Type Coffee Vending Machine	Model KORO PRIME	N° T.I. 01 - 2019
Serial Number 90810314	Subject Replacement of the "NiMh" battery with "lithium" battery	ISSUED FOR (X)
		Action Information X

Type Coffee Vending Machine	Model KORO PRIME	N° T.I. 01 - 2019					
Serial Number 90810314	Subject Replacement of the "NiMh" battery with "lithium" battery	ISSUED FOR (X)	<table border="1"> <tr> <td>Action</td> <td></td> </tr> <tr> <td>Information</td> <td>X</td> </tr> </table>	Action		Information	X
Action							
Information	X

New
CPU - Actuator board 16 Bit 4M

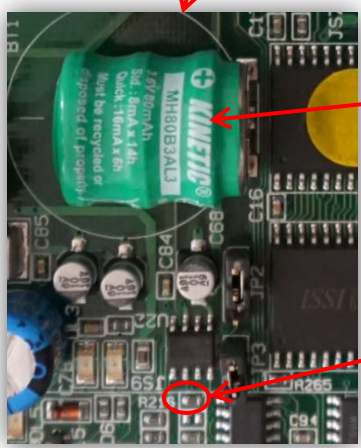
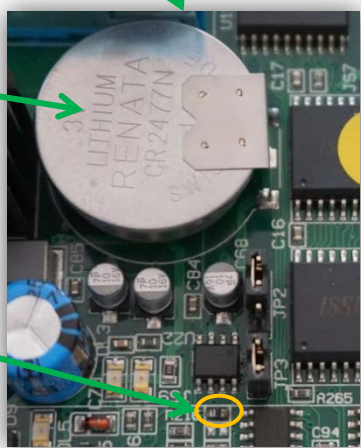
The **NiMh** battery has been replaced by a **lithium** battery.

In addition, the **resistor** has been replaced by a **schottky diode**, which prevents the current from reaching the **lithium** battery, when the machine is connected to the mains.
